8562EC-11**S E R V I C E N O T E**

Supersedes:
NONE**8560EC Series Portable Spectrum Analyzers****Serial Numbers: ALL****LCD Assembly Lower Level Part Numbers****Parts Required:**

October 9, 2013

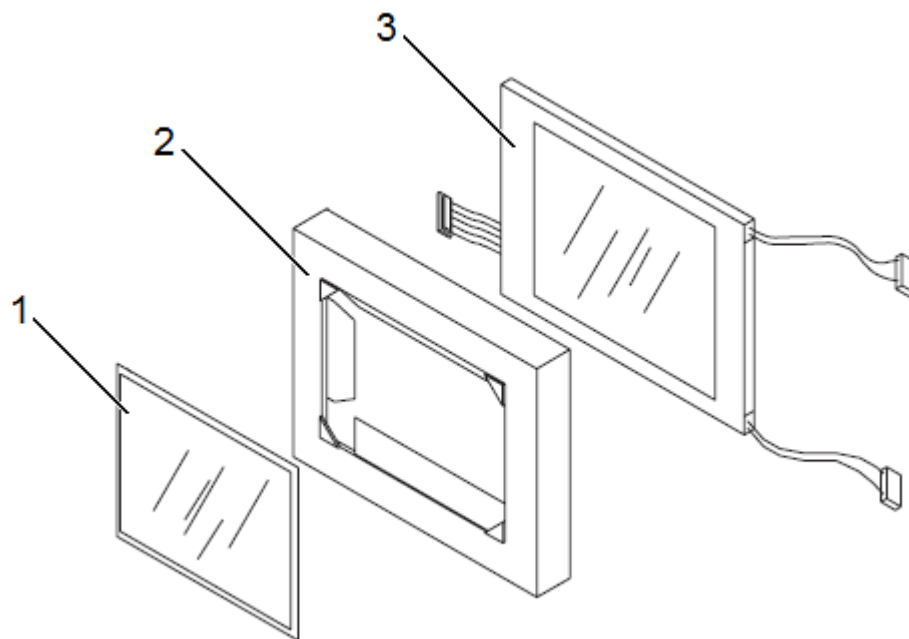
The 08563-60170 replacement assembly has been widely used when the LCD panel needed to be replaced. However, this assembly now includes two lower level parts that are in a Life-Time Buy (LTB) status. Since only one of these two parts would typically be needed for a repair the replacement assembly has been discontinued so that both LTB parts would not be consumed when only one would be needed.

When a replacement LCD is required, instead of ordering the 08563-60170 assembly, order only the lower level part listed below that is required.

Item #	Description	Part #
1	Glass LCD Filter	1000-1014
2	Rubber LCD Mount	5041-9632
3	LCD Panel	2090-0379
